Application No.  
**17/00524/FUL**  
Site Address:

**Land Adjacent To 6 Parkland Drive Bracknell  
Berkshire**

Proposal: **Erection of a 2 bedroom dwelling adjoining to no. 6 Parkland Drive.**  
Applicant: Mr Mark Davies  
Agent: Mr Peter Charman  
Case Officer: Michael Ruddock, 01344 352000  
[development.control@bracknell-forest.gov.uk](mailto:development.control@bracknell-forest.gov.uk)

## **OFFICER REPORT**

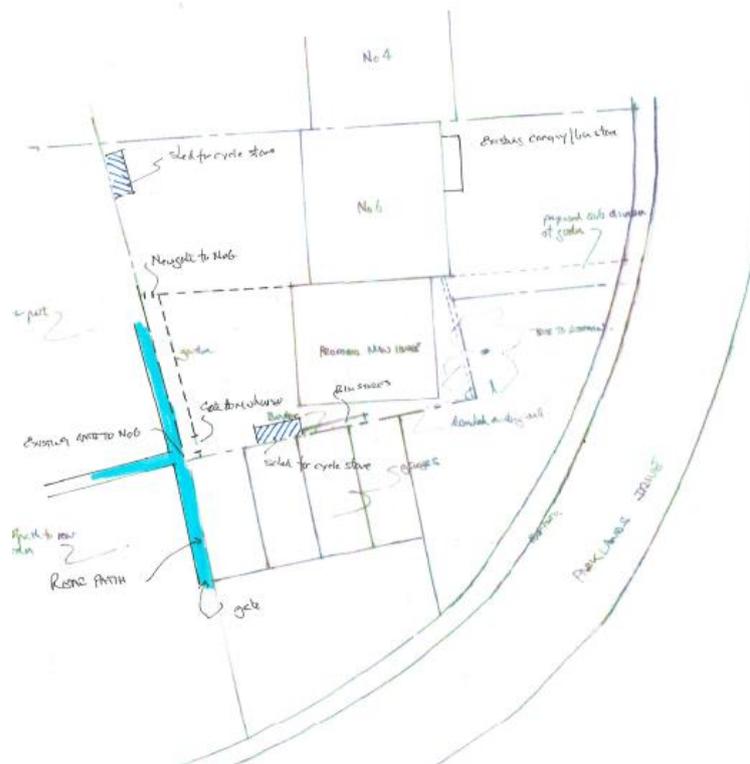
9.22 Pedestrian access to the front door of the new dwelling is shown. The new dwelling would have a side access between the dwelling and the garage, and an existing rear access to No.6 would remain along the rear of the garden of the new dwelling. These would provide access to cycle storage sheds in both gardens as well as the new bin storage area to the side of the new dwelling which shall be secured by condition. A separate door to a storage area and a canopy are provided for bin storage at the existing dwelling and this would remain. The below plan shows the rear access, bin storage and cycle storage areas for both dwellings.
